Subject: Addendum No. 1 to Bid Documents

Heartland East 23-24 Batch and Build Edge-of-Field Project- Bid No. EOF-24-01
Cedar, Scott, Johnson, and Muscatine County, Iowa"

Description: The purpose of this addendum is to document a change in a saturated buffer design. Specifically, ESE has changed the WCS from a standard 6 ft by 6-inch 3-chamber to a custom 6 ft by 8-inch 3-chamber with 6-inch flex couplers to fit the existing tile for the Section 18 - T79N - R04W Saturated Buffer in order to meet the future instrumentation needs of researchers at the University of Iowa. The change has been noted in yellow font on Sheet 2 as well as in red font at the top of Sheet 6 and in the "Quantities" table on Sheet 6 in the attached file titled "S18-T79N-R04W Saturated Buffer Constdocs_V2_5-21-24". This is the only file that has been modified to reflect this change.

SATURATED BUFFER CONSTRUCTION PLANS

3 CHAMBER STRUCTURE DETAIL

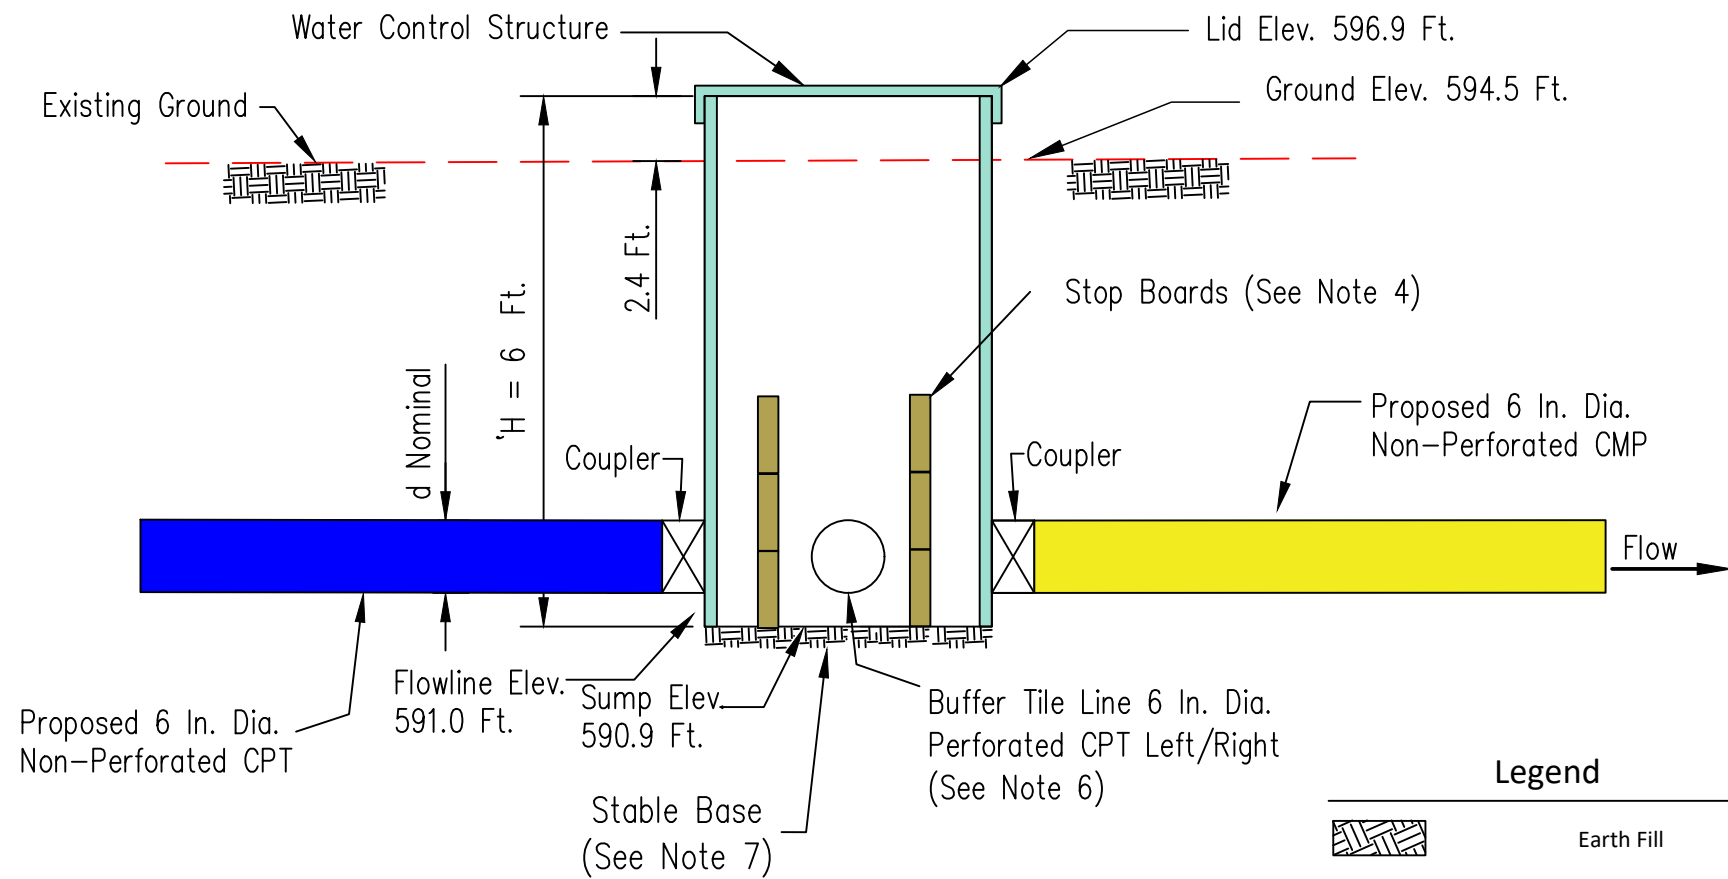
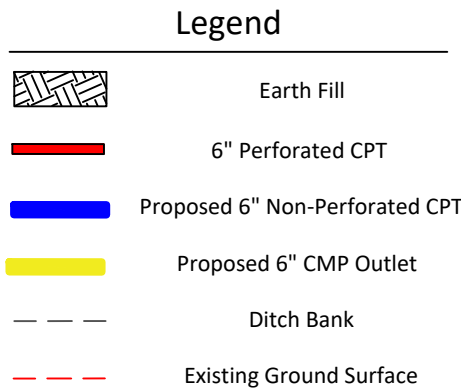
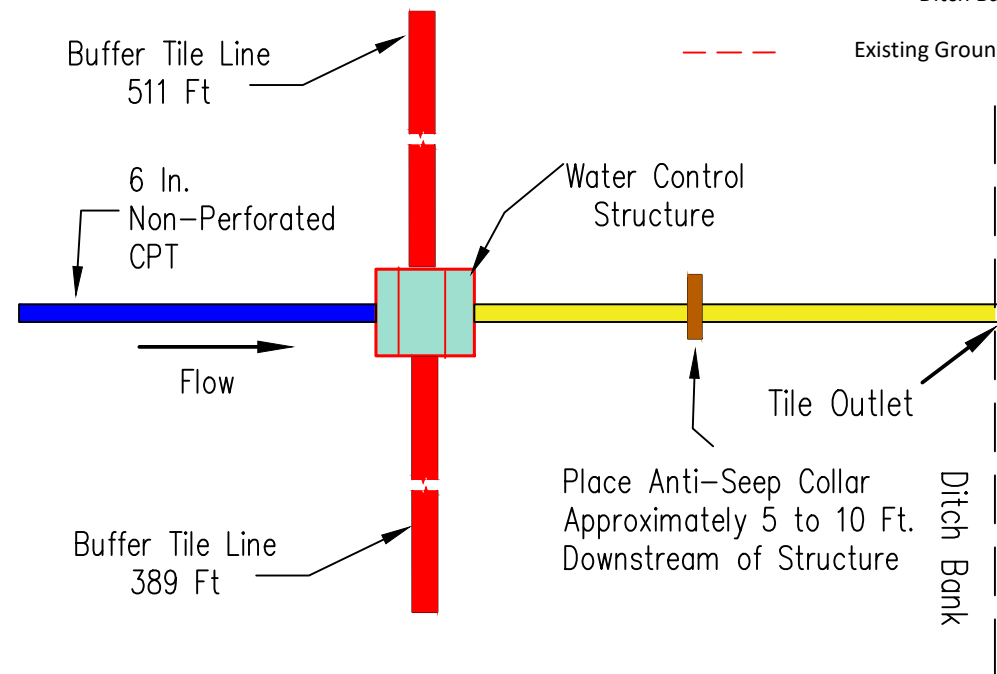
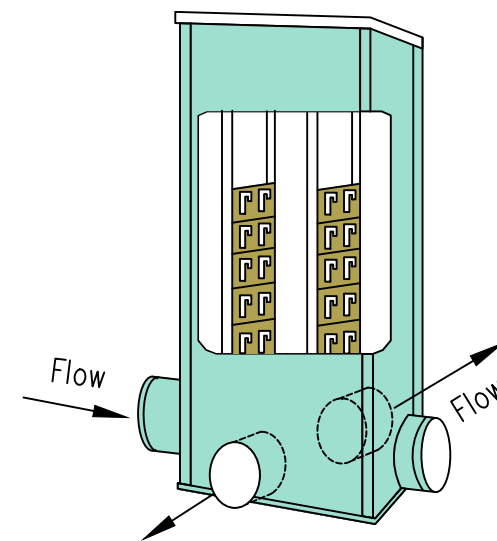
5/21/24 – Updated Structure to 8" box size with 6" flex couplers to fit existing tile

QUANTITIES*		NRCS SPEC
Water Control Structure 3- Compartment H = 6 ft. d = 8". box with 6" flex couplers	1	IA-21, IA-26, CPS-587
6" Non-perforated Pipe (ft)	20	IA-21, IA-45
6" CMP Outlet Pipe with Rodent Guard (ft)	35	IA-604, IA-620
6" Perforated CPT (ft) Buffer Tile Line	900	IA-21, IA-45, IA-46
3'x3' Anti Seep Collar	1	CPS-587
